Re: LC 71 - NW Natural's 2018 Integrated Resource Plan Update - Reply Comments

**THIRD UPDATE TO NW NATURAL'S 2018 INTEGRATED
RESOURCE PLAN**

OPUC DOCKET LC 71

NW NATURAL'S REPLY COMMENTS

Figure 2 - Histogram of Winter Temperatures (Nov-March) since 2009

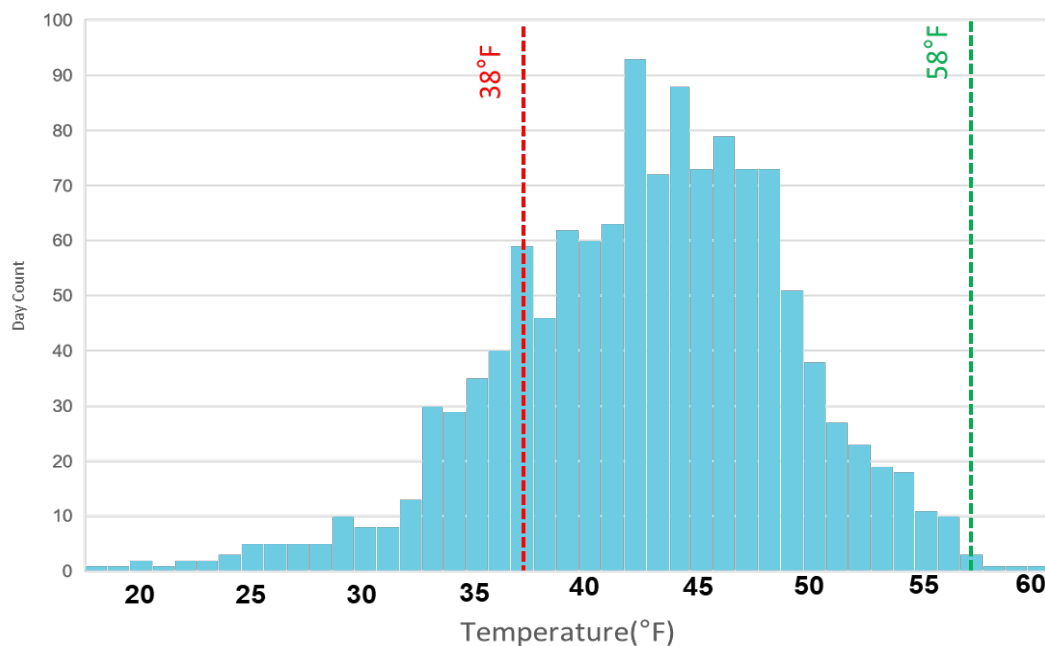
In regards to Staff's first concern about parsimony of the model, NW Natural understands how, all else equal, increasing the number of independent variables in a regression reduces the degrees of freedom and can lead to overfitting the model. However, by including interaction terms into the daily system load model the Company can account for non-linear interaction effects across a wider range of temperatures. This allows for far many more observations to be included into the model to estimate/predict load at peak day temperatures, which in turn leads to more degrees of freedom and less risk of overfitting the model.

The peak day temperature that the Company is planning for is about an 11°F day. This is several degrees colder than any data points in the training data set for the model with load data going back to 2009.²⁴ Figure 2, shows a histogram of temperatures used in the daily system load model for peak planning.²⁵

Figure 4 - Firm Sales Model with Interaction Terms

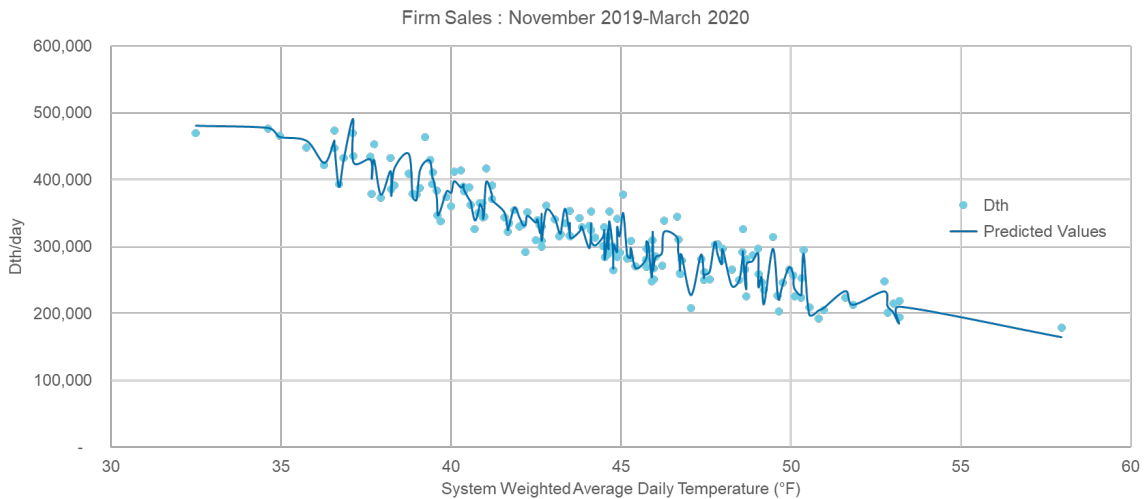
“(A) forecasting principle of parsimony when selecting load forecasting interaction terms, including them only when they are believed to help explain changes in the load forecast.”²⁰ They continue that “(U)sing multiple interaction terms has a risk of overfitting of the load forecasting models, while Staff’s recommendation of a forecasting principle of parsimony can prevent model overfitting.”²¹

Figure 4 zooms down to a single heating season (November 2019-March 2020) and shows predicted values using the model with interaction terms. This model accounts for variation beyond temperature and performs far better at the coldest temperatures than the temperature only model. Performance at the coldest temperatures is the key metric for this model, since its primary purpose is estimating peak day load.

Figure 5 – Figure 3.36 from the 2018 IRP

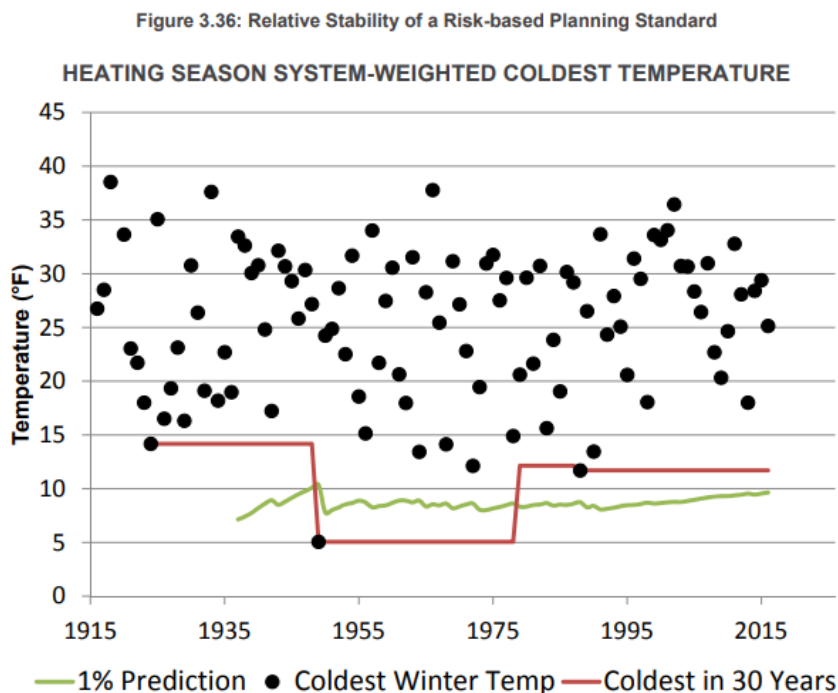
Staff's second concern is the with the probabilistic approach to forecasting peak capacity need, specifically the length of the data series used to establish NW Natural's capacity need. *“Staff’s concern is that the Company is including too cold of a peak day.”²²* Referencing Figure 3.36 in

the Company's 2018 IRP, Staff concludes the figure, "shows that the coldest day under the new methodology is above the actual coldest day in 100 years but below the coldest day in the most recent 30 years."²³

"...that the Company is including too cold of a peak day. For instance, in the figure above [Figure 5], the most recent 20 years of data visually would have a very significantly warmer coldest day than the Company's new 99 percentile approach²⁹."

The day Staff is referring to occurred in 1989 with a temperature of 10.5°F. Even though the 10.5°F temperature in 1989 is above the 1% (illustration-only) prediction line, the combination of other weather load drivers that occurred that day (e.g., wind speed that equaled 22 mph that day) placed that day higher than the 99th percentile in terms of load. Using the same weather from February 3, 1989 and applying current customer counts and trend values, the daily system load model predicts a load of 1,056,000, while the 99th percentile from the firm sales peak day simulation equals 997,000.³⁰

For additional context, Figure 5 shows historical coldest daily temperature values by gas year, but the 1% prediction line is based on simulated data from a normal distribution using historical data for each given gas year to define the mean and standard deviation of the distribution. In other words, the 2015 year in Figure 5 has 100 years of data to define the mean and standard deviation of the simulation, whereas the 1940 gas year, where a 5°F day occurred, only has 35 data points defining the mean and standard deviation. This is a main reason why the green line becomes more stable over time as more data points are included in the sample. For the 2018 IRP Update #3 data from 1938 through 2019 gas year for the coldest day in each gas year was used to define the mean and standard deviation of the distribution peak day temperatures.³¹

To reiterate, the 11.2°F mean from the simulation data around the 99th load percentile is the average of the peak day temperatures used for IRP planning. This is well above the green line 1% line shown in Figure 5 for illustrative purposes and slightly above the 10.5°F daily temperature seen on February 3, 1989.

Figure 7 – Probability of 1-in-100 event occurring less than 30 years apart

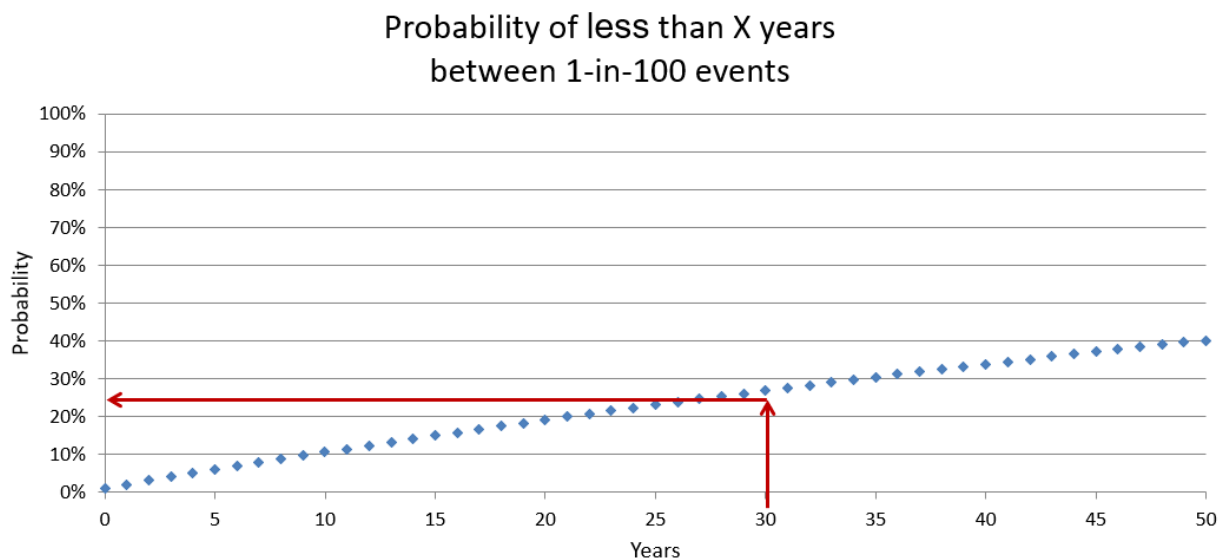
Lastly, Staff's concern related to Figure 3.35 in the 2018 IRP relates to using a negative binomial distribution. The negative binomial distribution is used for illustrative purposes only. Figure 3.35 in the 2018 IRP is used to illustrate that using the highest load requirement in the past 30 years is not the equivalent of the planning for a 1-in-30 event. In fact, from our simulation, the Company has shown that given the high wind speeds and severe cold temperatures seen on February 3, 1989, this event exceeded a 1-in-100 year event. An additional figure, Figure 7, was shared during a TWG, but not included in the IRP.

Figure 7 demonstrates that even though a 1-in-100 year event was experienced a little over 30 years ago, another 1-in-100 year event still retains a positive probability of occurring even in the following year. The negative binomial distribution is only used for this demonstration to express the advantage of using a probabilistic planning standard and is not used in the actual Monte Carlo simulation for peak day firm sales load.
